**ADDENDUM TO TECHNICAL DRAINAGE STUDY
FOR
*Kyle Canyon Road and Oso Blanca Road***

**JOB NO. 200203
AUGUST 2022**

COMMENT LETTER

ULTIMATE CONDITION (RATIO CALC. FOR OFFSITE FLOW)

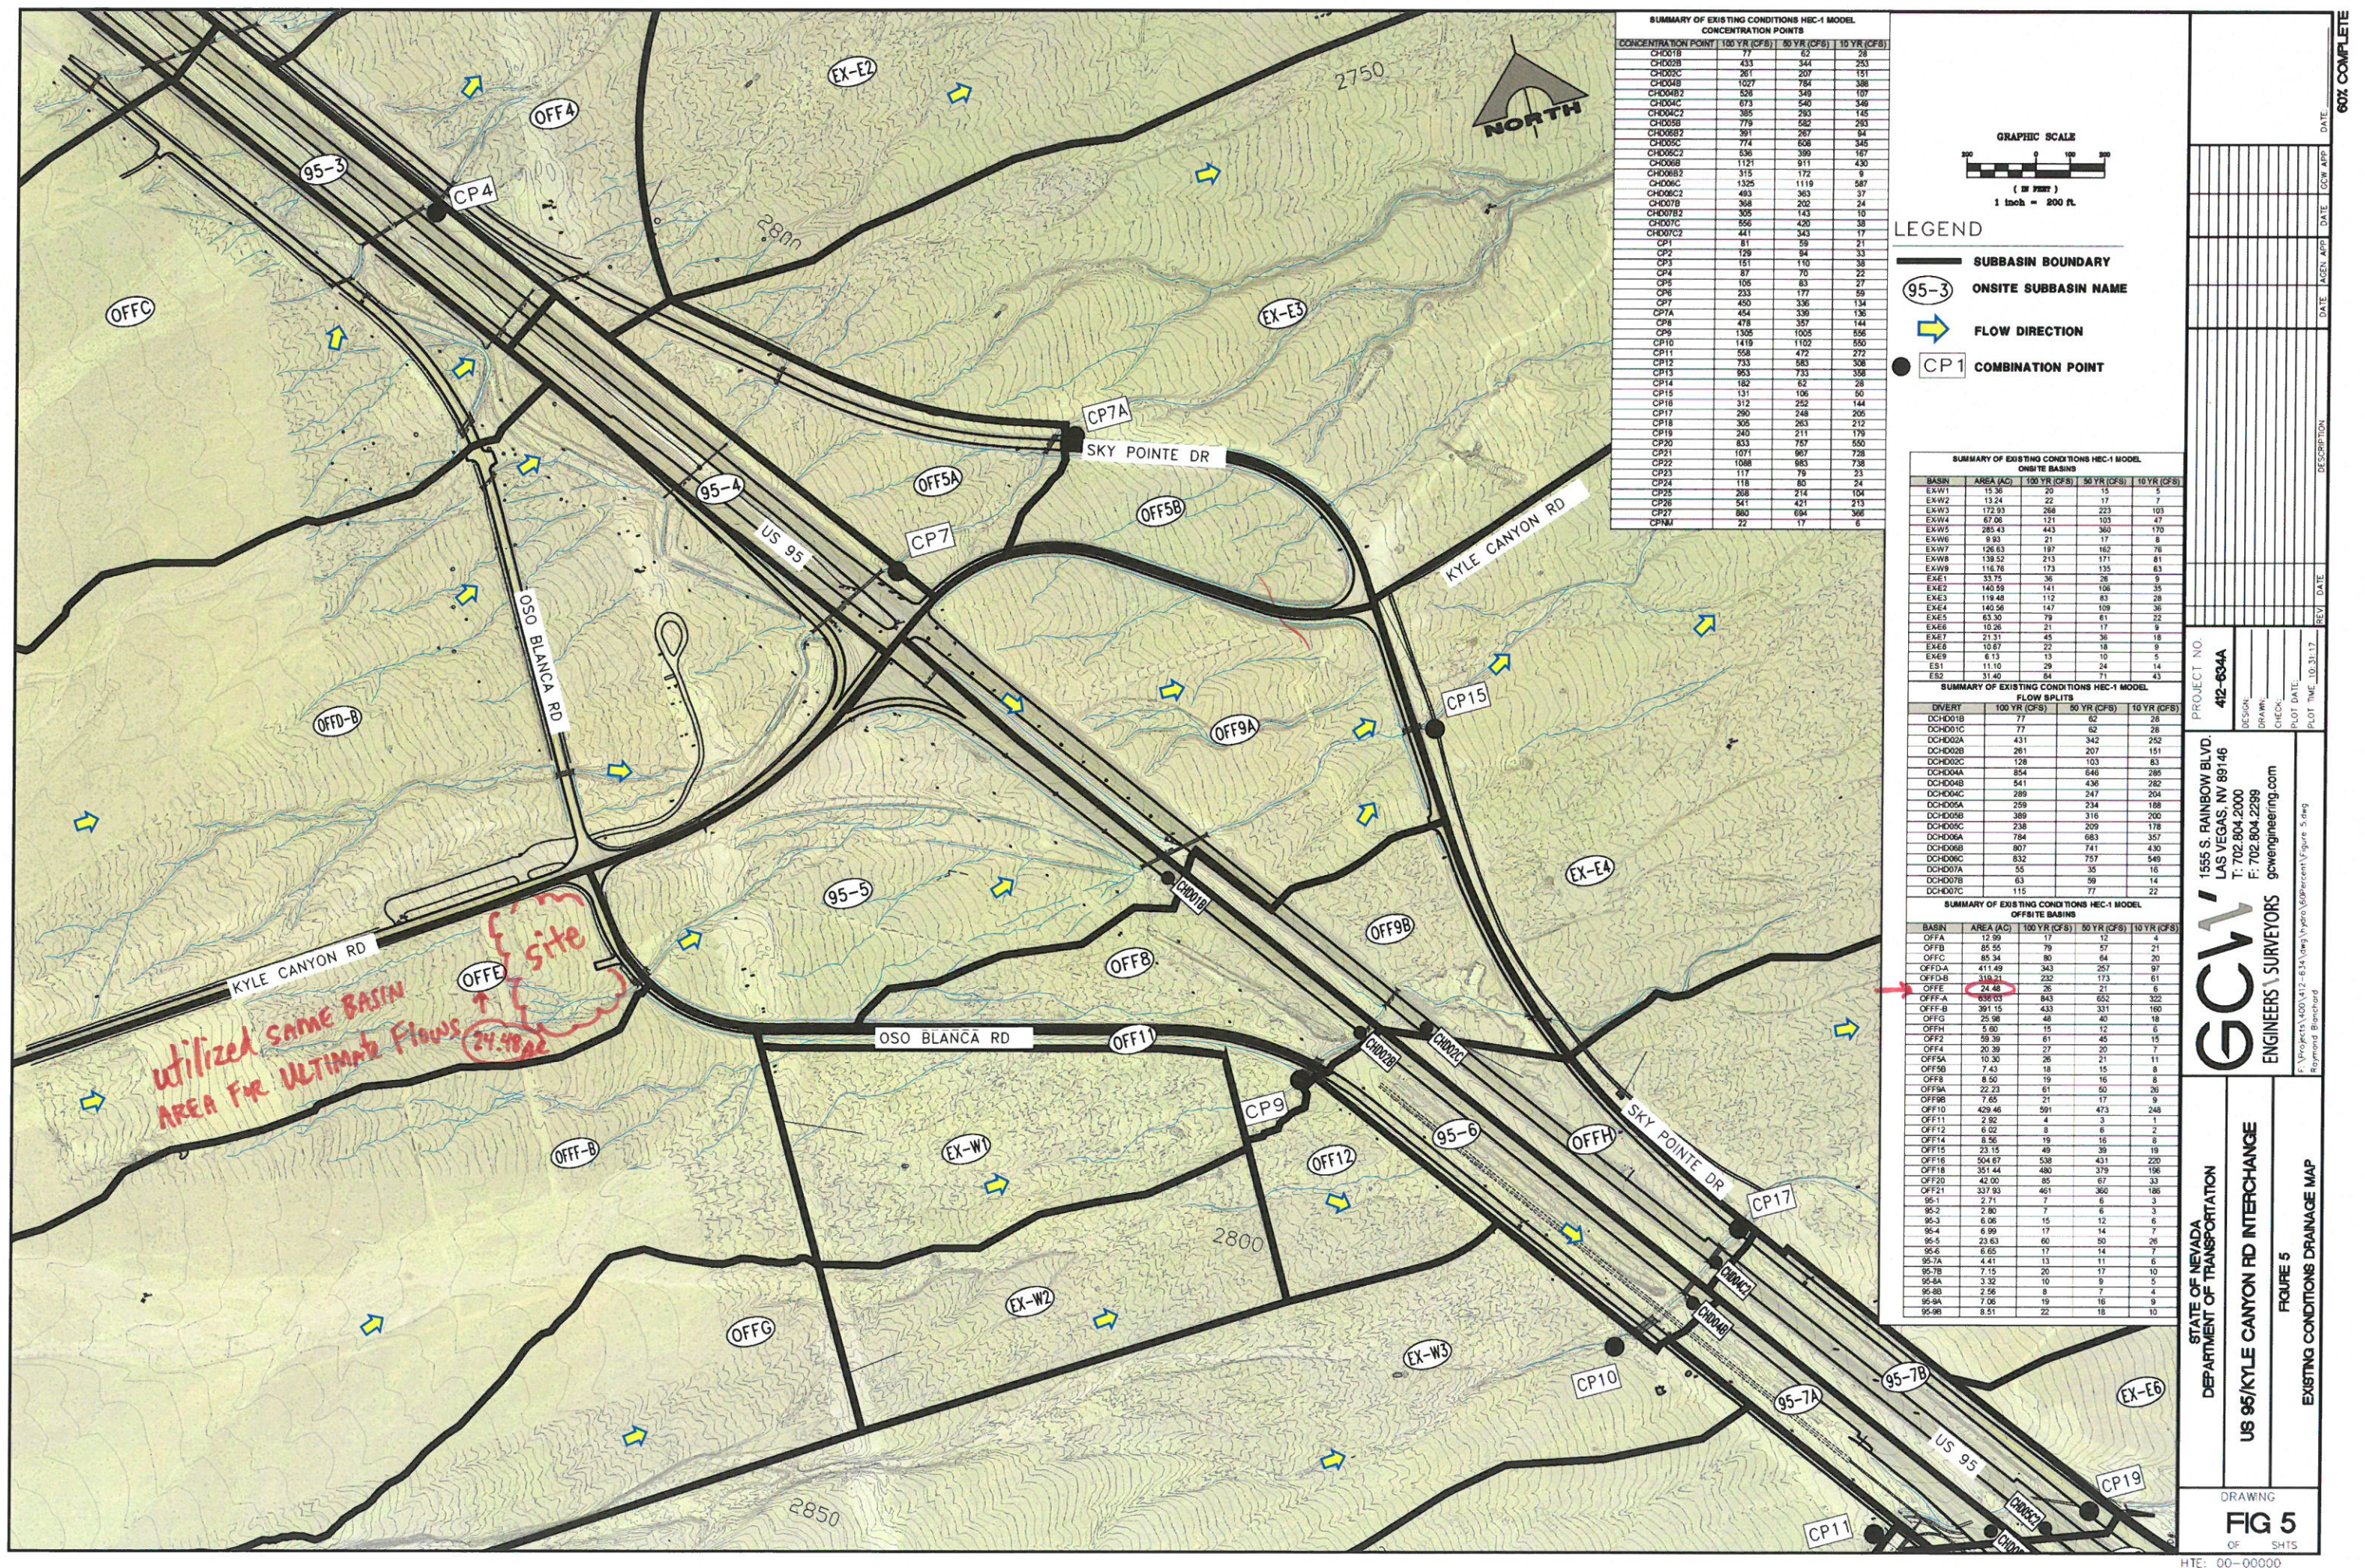
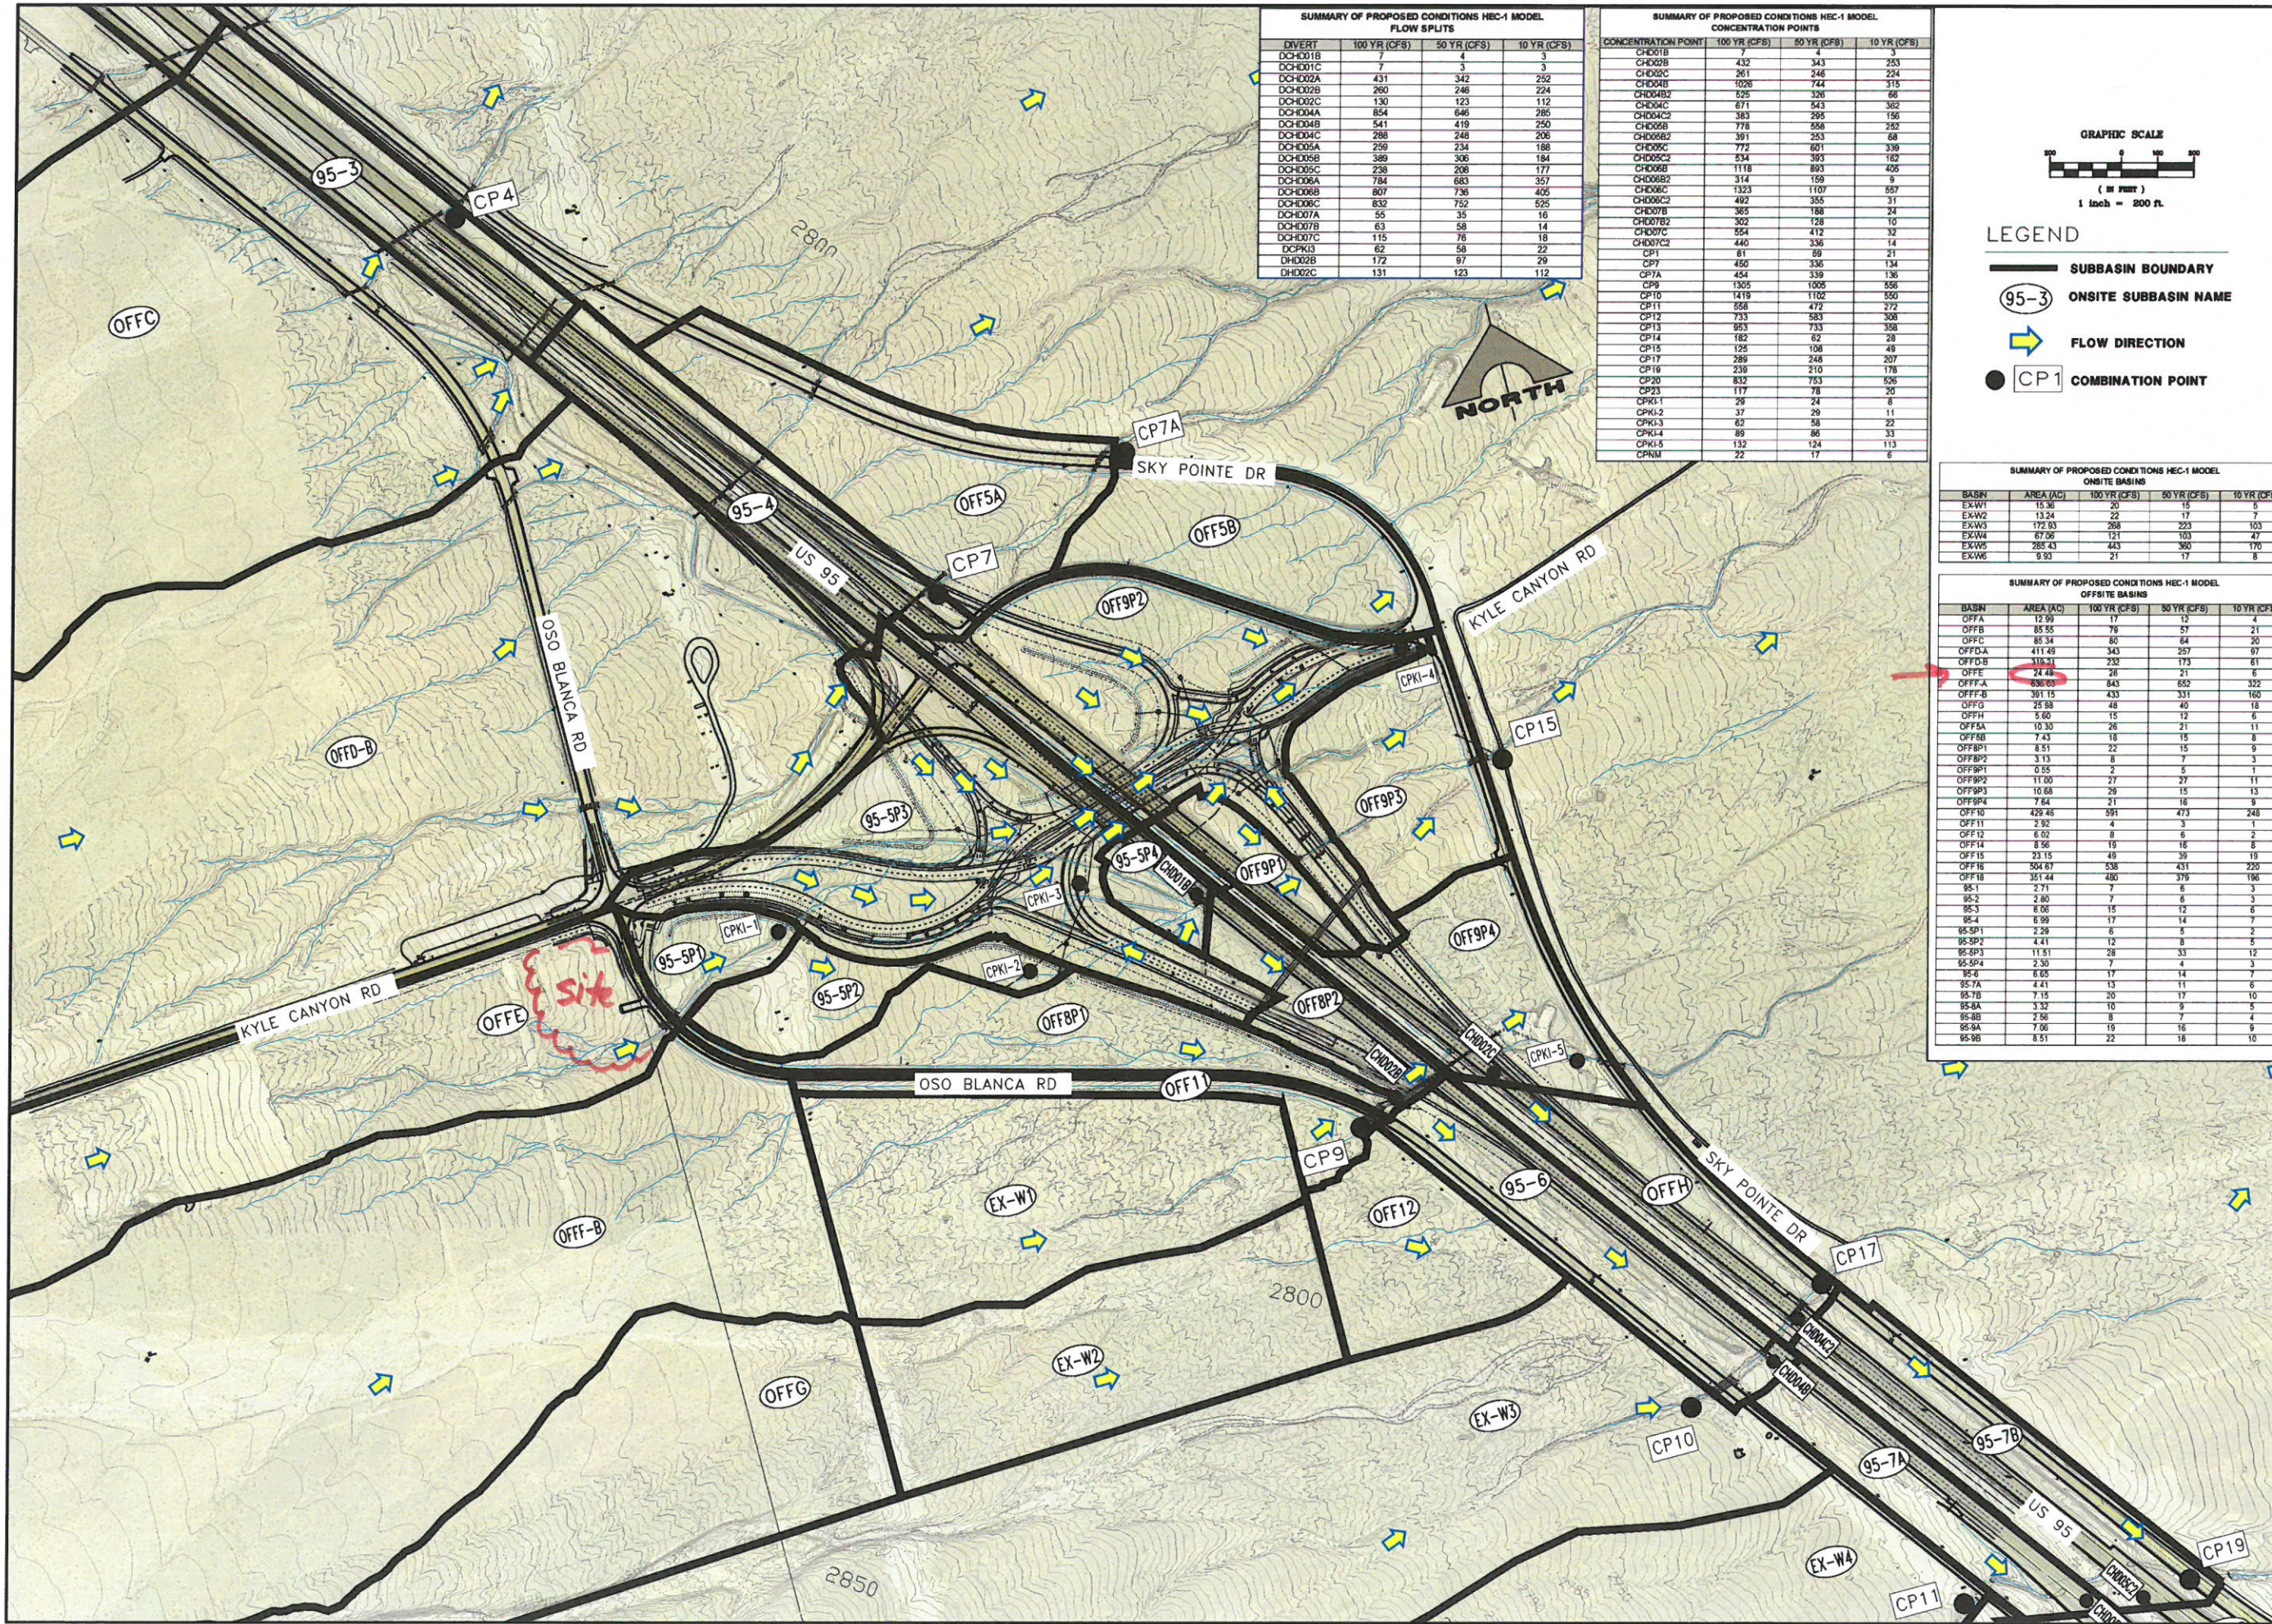
- 4) Provide an *Ultimate Drainage Map* that accounts for the offsite basin OFFE under developed condition. *Ultimate Condition* shall be the worse-case condition over the *Developed Condition* and presents the highest runoff situation.

Response 4: In the initial submittal, we included approved Exhibit H, which is the Ultimate Condition Drainage and Facility Map. This Exhibit H has been re-included. On this Exhibit, the future ultimate condition facility at the downstream end of our Site shows Facility ID E-7. Facility E-7 was shown to be designed for 44cfs for Ultimate conditions. This is what we initially submitted for and designed our drainage facilities for. Our site and offsite area is a small portion of the future offsite basin NW35-C (192 acres; 423cfs/260cfs/191cfs), which discharges 191, 260 and 423cfs in the 10yr, 25yr and 100yr storm events.

Using offsite Area of 'OFFE' (24.48 Ac), which is the Area that impacts our Site, A RATIO CALC. is performed for Ultimate condition using ultimate Flows from 'NW35-C'

$$Q_{100} - \frac{423 \text{ cfs}}{192 \text{ Ac}} = \frac{Q_{100}}{24.48 \text{ Ac}} \quad Q_{100} \approx \underline{\underline{54 \text{ cfs}}}$$

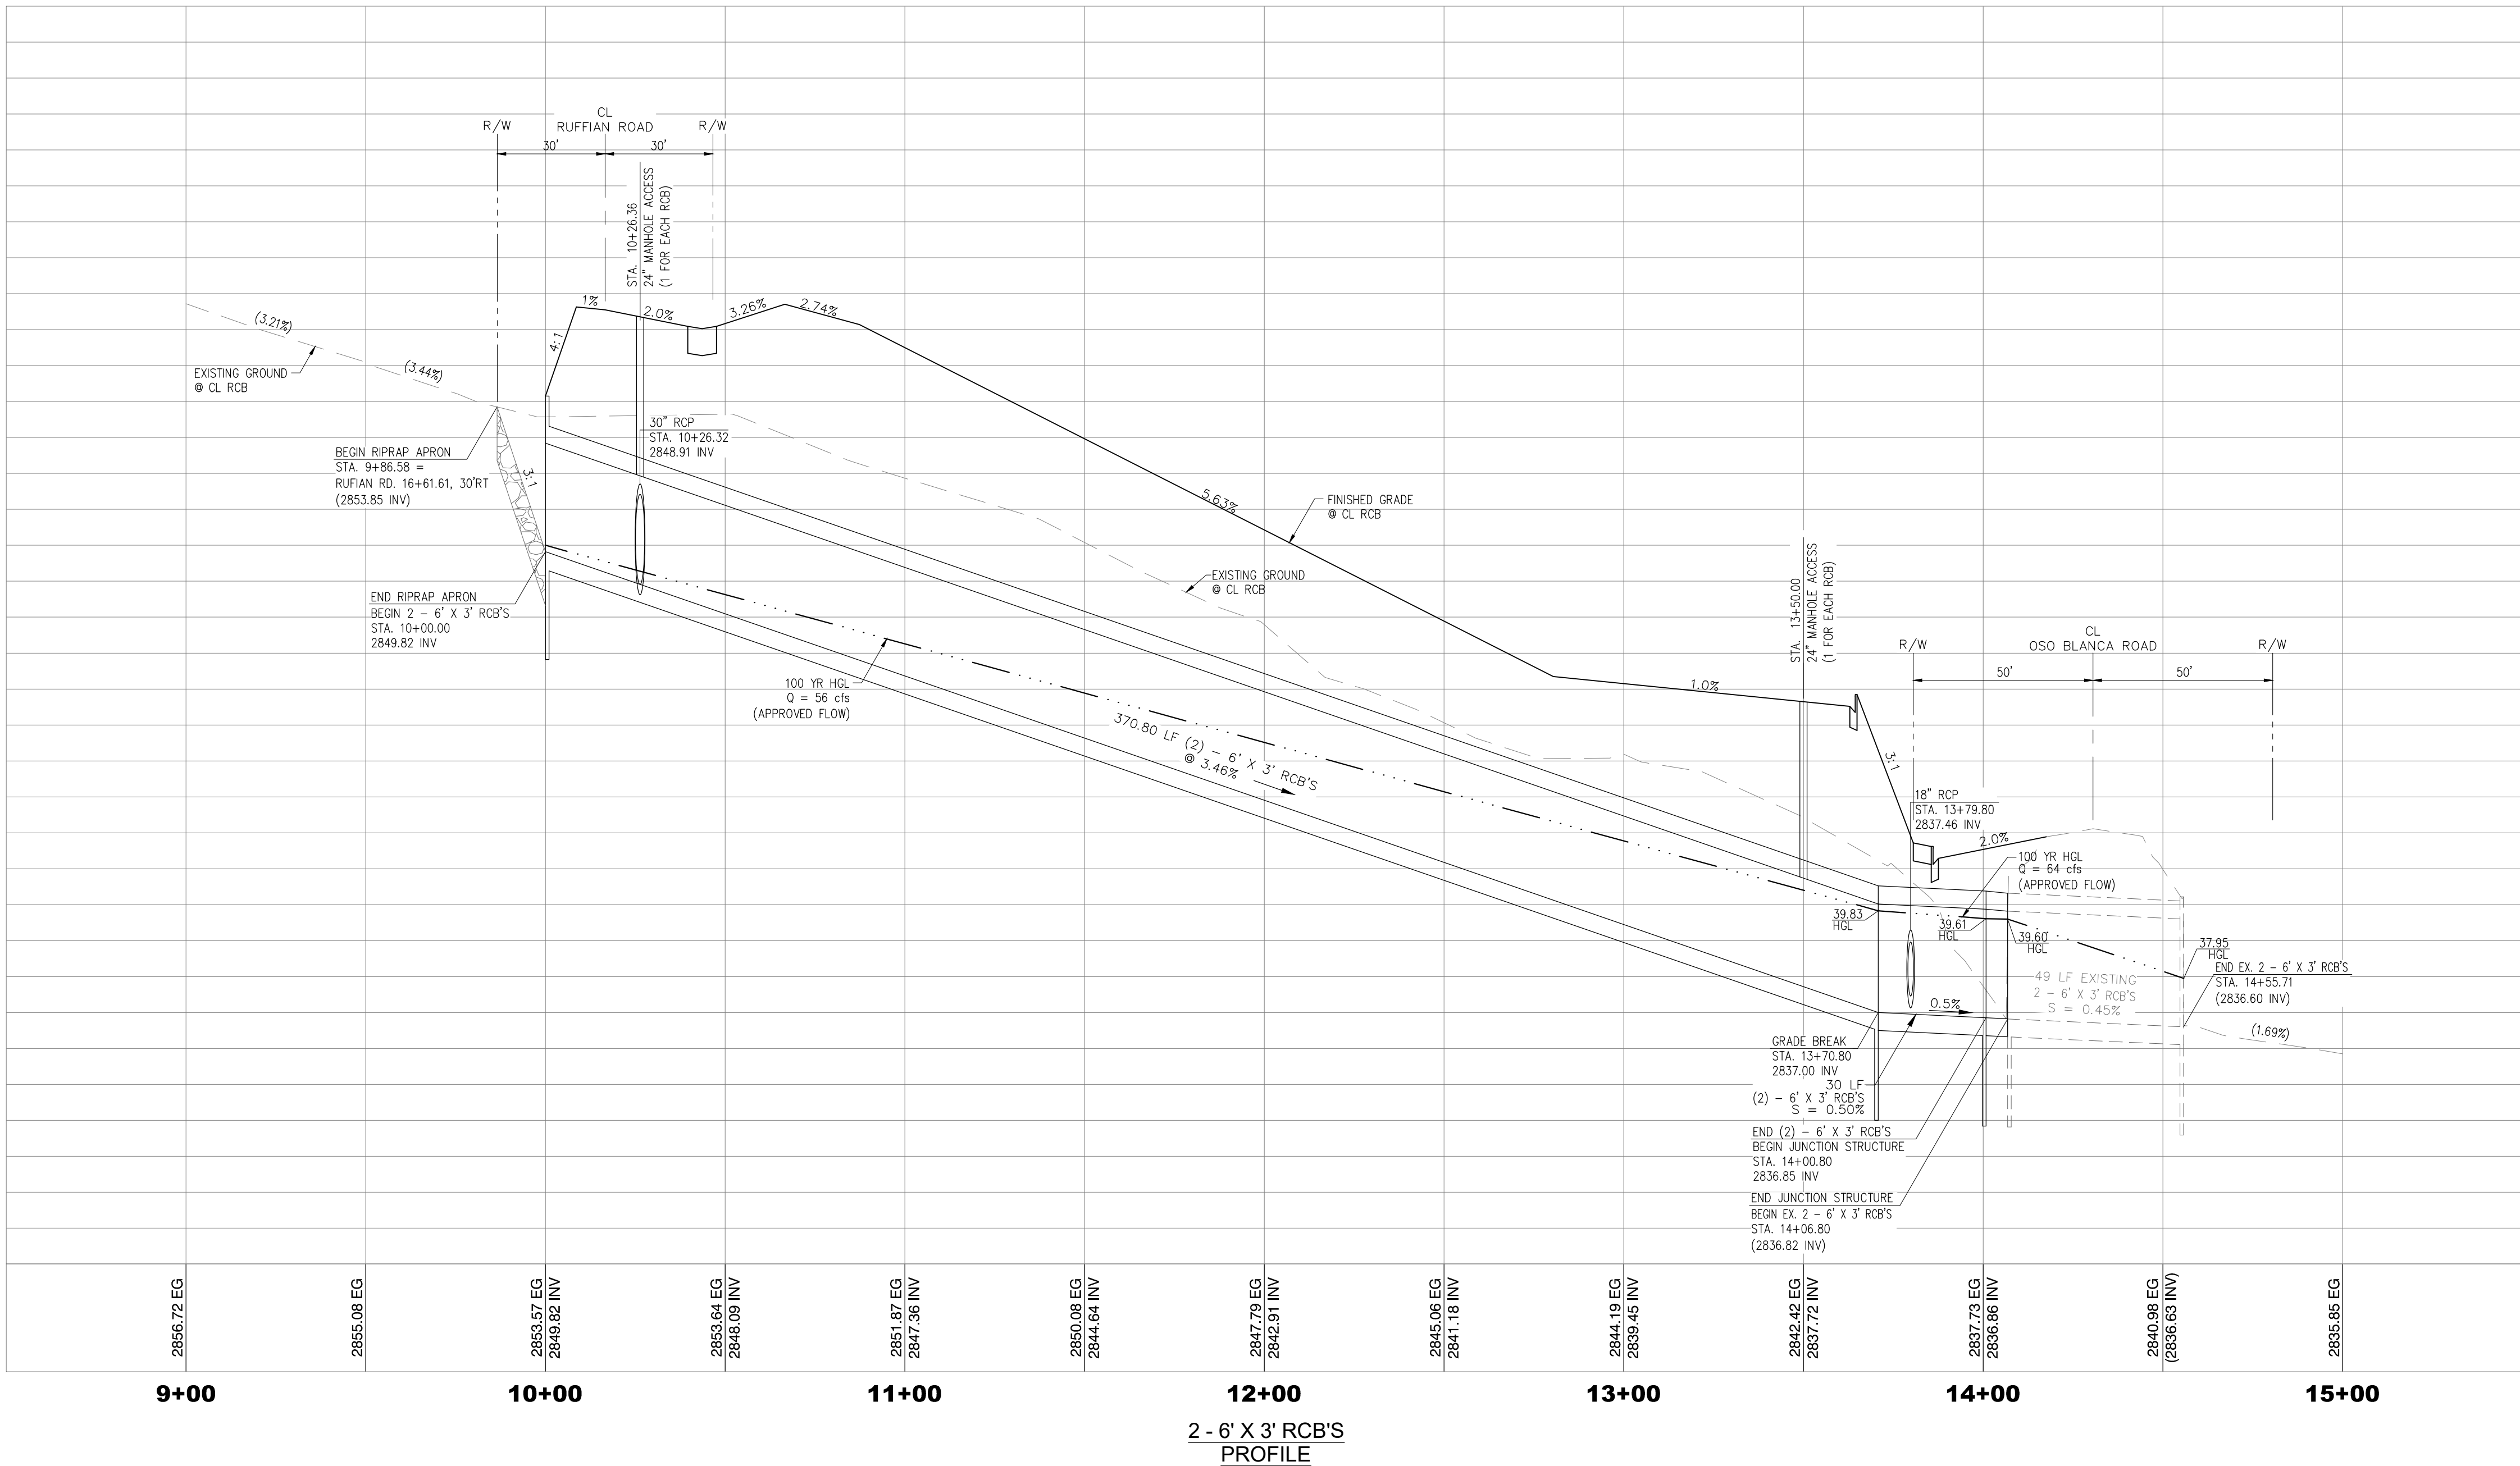
- 9) **Sheet C6:** Remove an existing 24"- RCP culvert in *Oso Blanca Road* at the proposed driveway location. Provide a note for such action.

Response 9: Noted.

- 1) REMOVE EXISTING 24" RCP STORM DRAIN PIPE.
